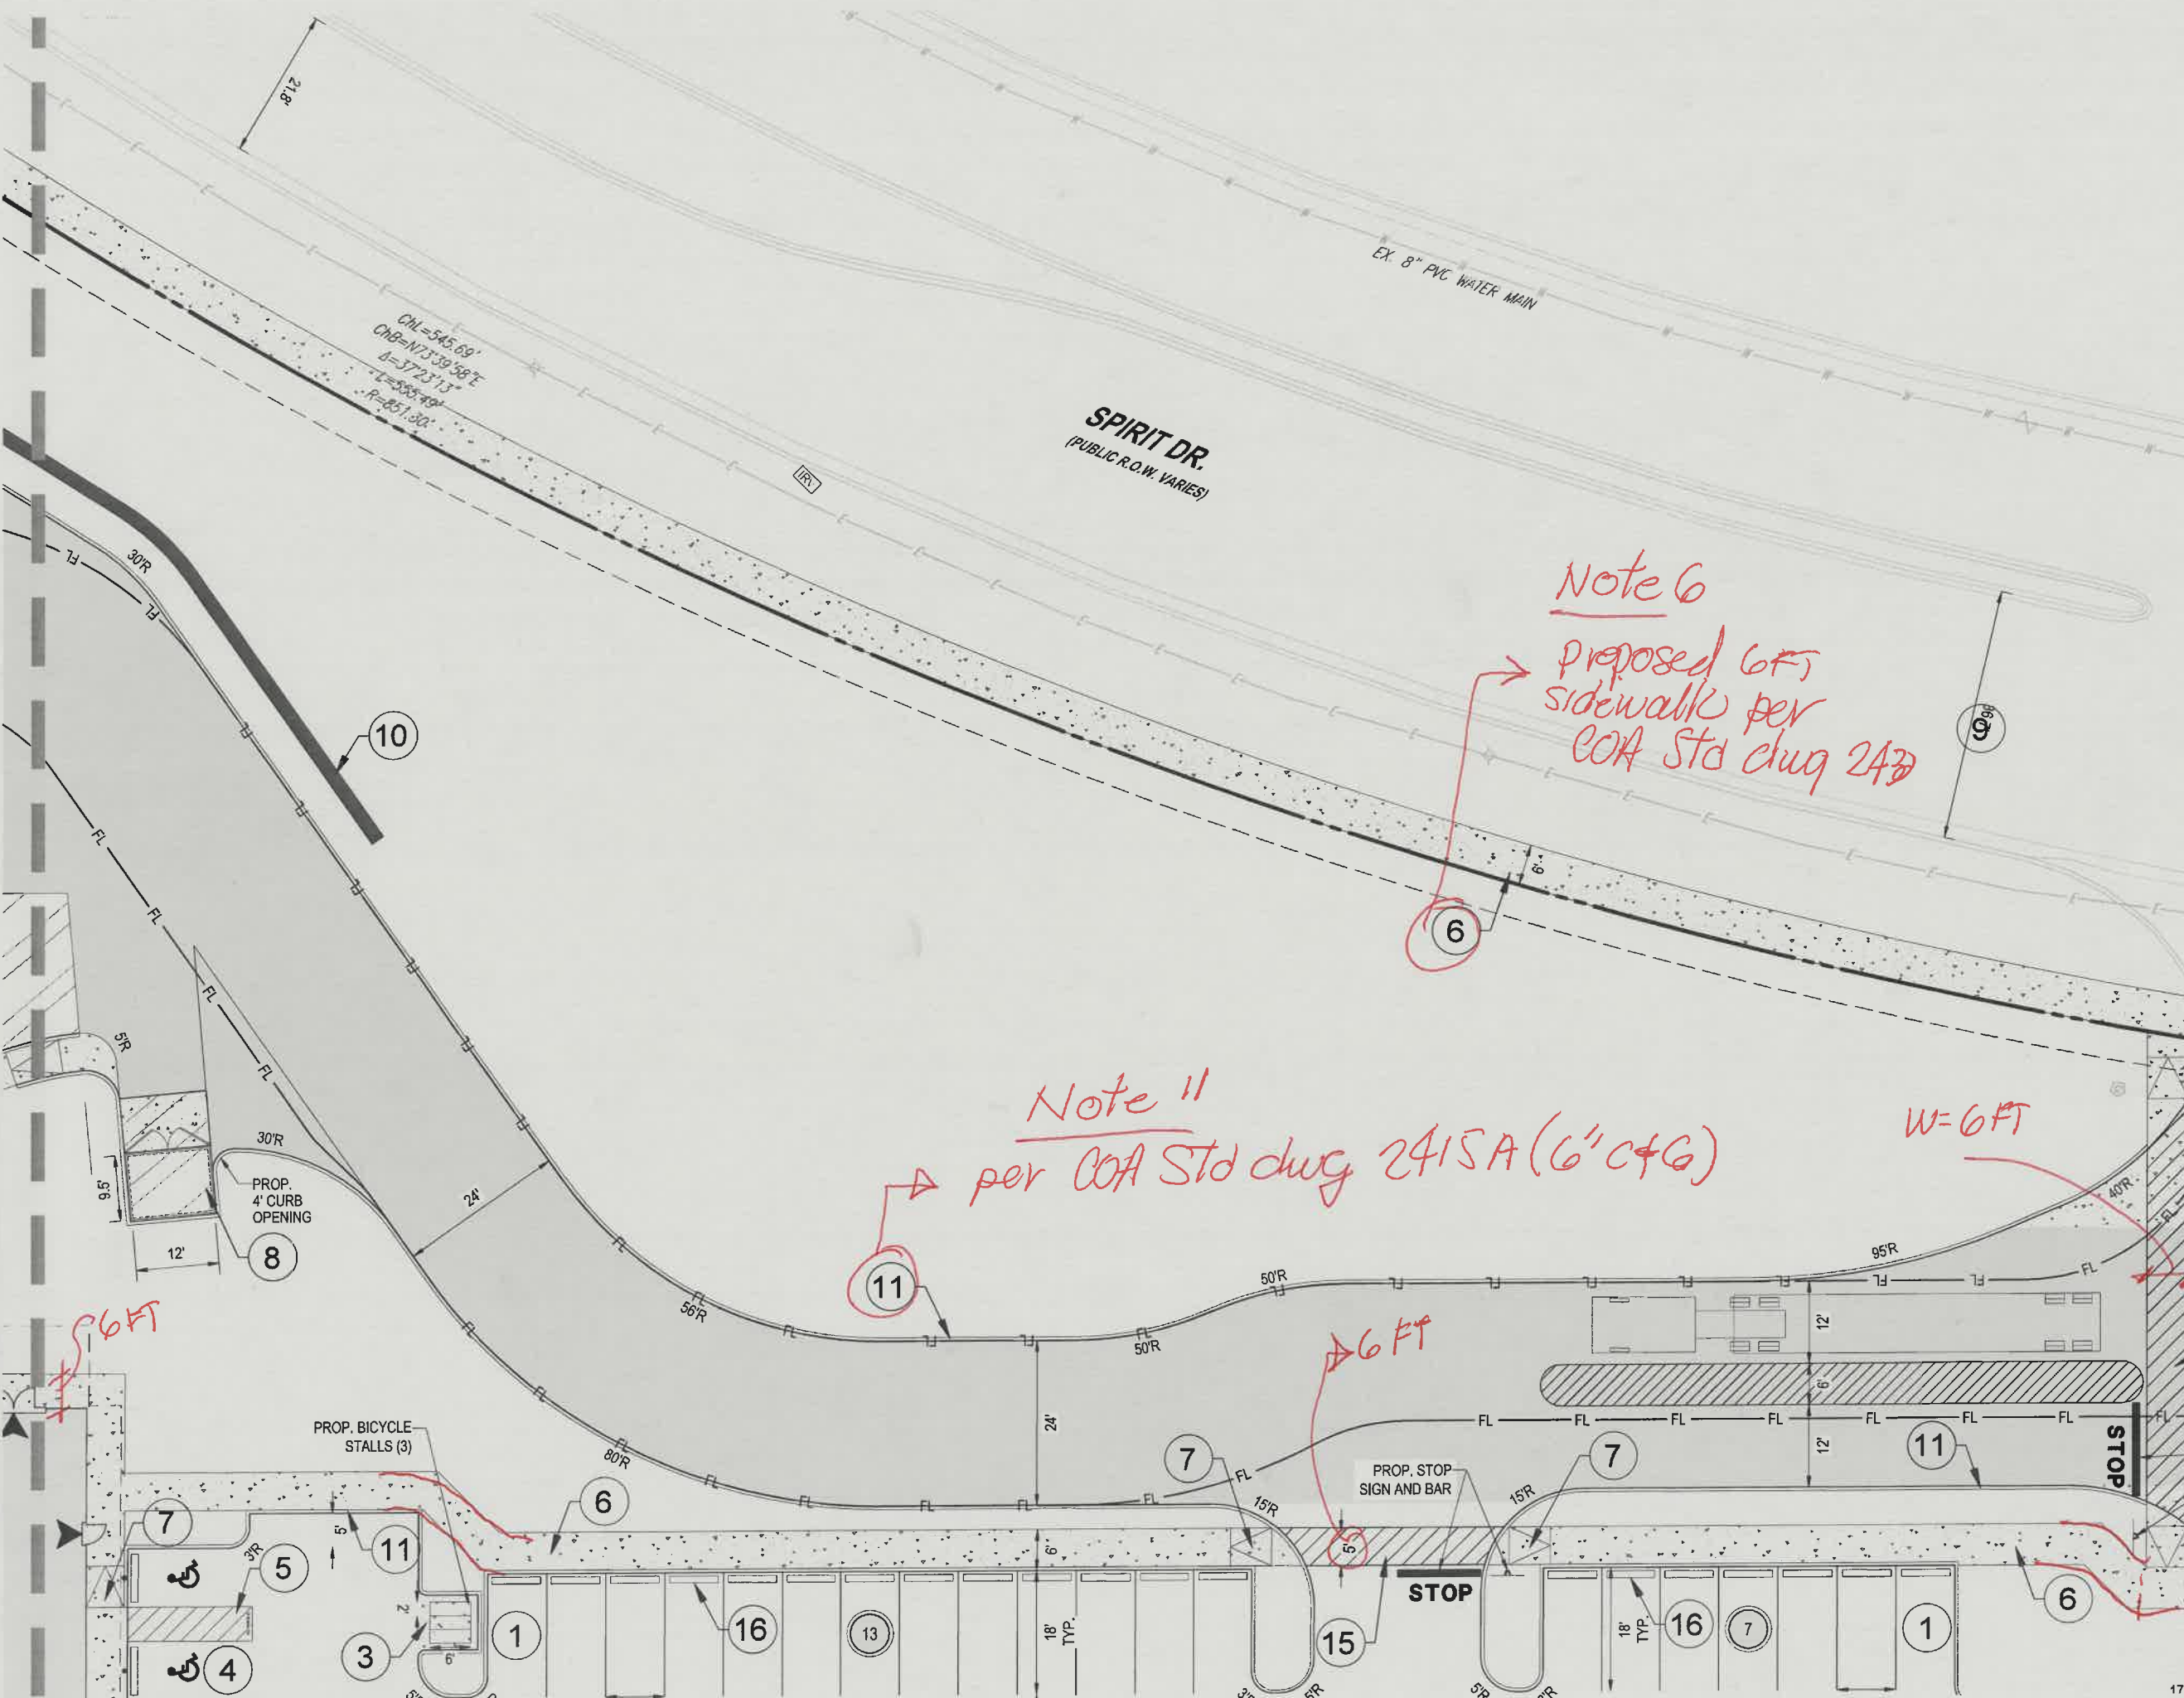
Add note: provide 4:1 tie taper to existing elevation

* please Reference detail sheets for all proposed infrastructure

Proposed ADA ramp per COA Std dwg 2445

Reference Sht. 907 and adjust ADA accessible space/aisle to it!!!

Reference

Ramp detail C, Sht C-902

① provide MC -> pmt. markings.
② Motorcycle sign

why?

6' PT

landings 2' min 6'x6'

provide curve radii's

Note 6
 proposed 6' sidewalk per
 COA Std chug 2420

Note 7
 Proposed ramp
 per
 COA Std chug
 2445
 or
 Reference
 Sht. C-901 & 902
 for corner
 ramps

Note 11
 per COA Std chug 2415A (6' C+G)

W=6' FT

6' FT
 PROP. CONCRETE
 VALLEY GUTTER
 per 2420

Reference
 Sht. C-901

Add note:
 taper C+G
 to zero
